PERMIT
SEWAGE DISPOSAL SYSTEM
HOWARD COUNTY HEALTH DEPARTMENT
BUREAU OF ENVIRONMENTAL HEALTH
410-313-2640

SUBDIVISION Dill LOT NUMBER 10 ADDRESS 3952 Sharp Road

SITE INSPECTION SHEET

OWNER: Andrew WarrenADDRESS: 3952 Sharp Road
Glenwood, MD 21738TAX & PARCEL: 21, 118

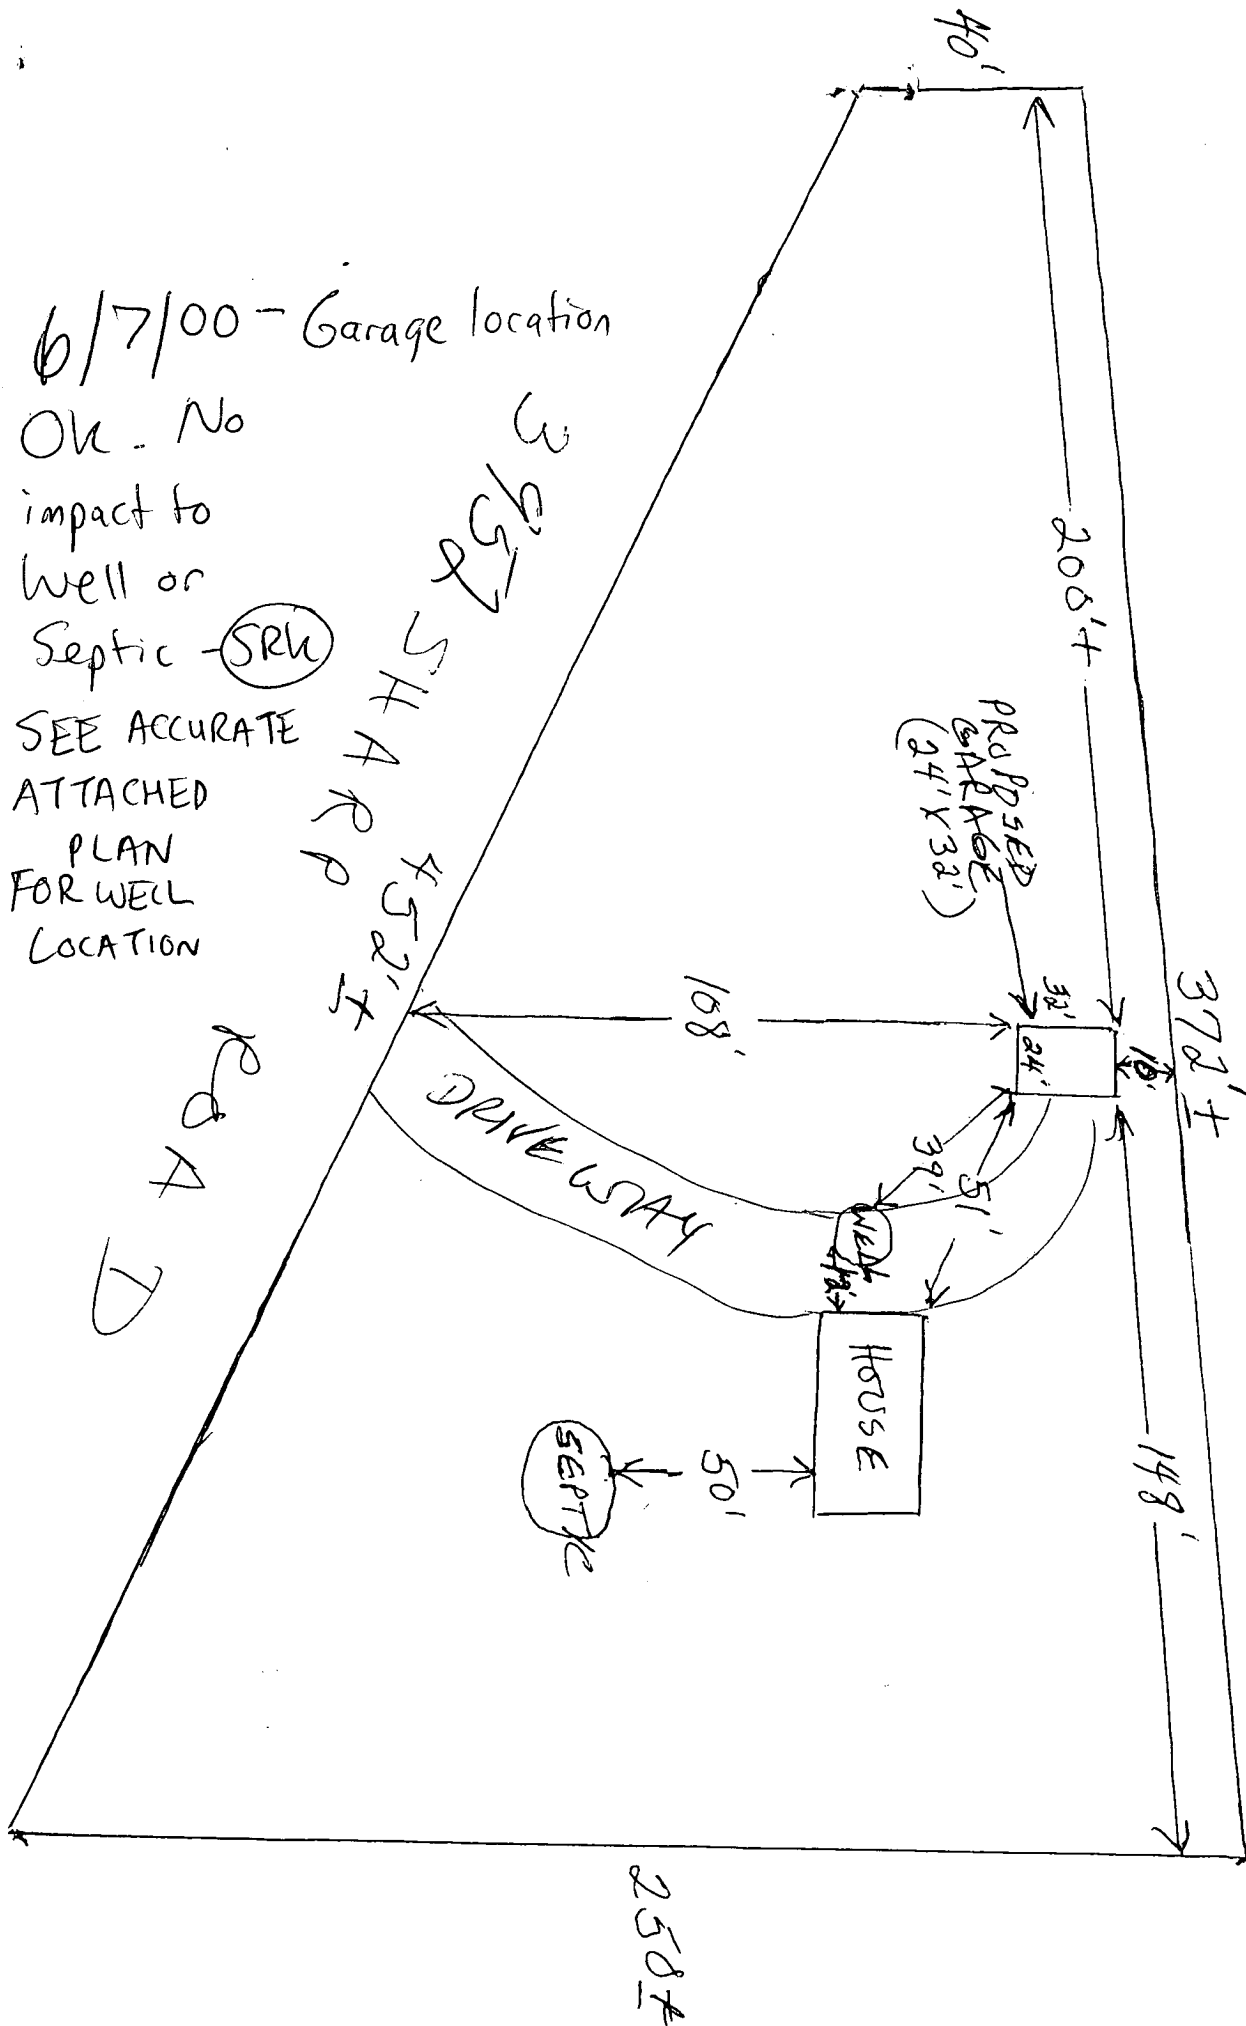
6/7/00 - Garage location

OK - No

impact to

Well or

Septic (SRH)

LOCATION DIAGRAM

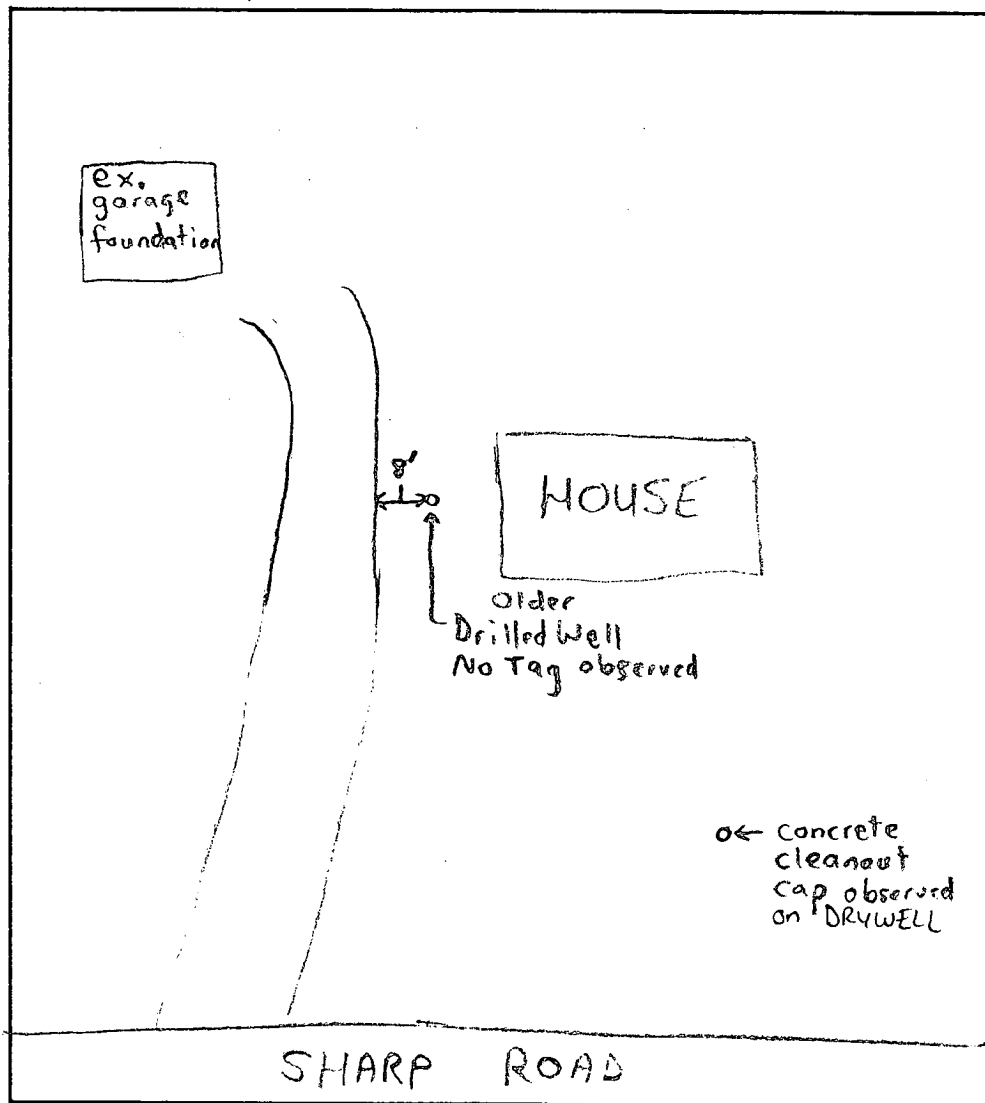
COMMENTS: Proposed Garage location has no impact to well or
septic. Met owner and discussed information.DATE: 6/7/00INSPECTOR: Steven R. King
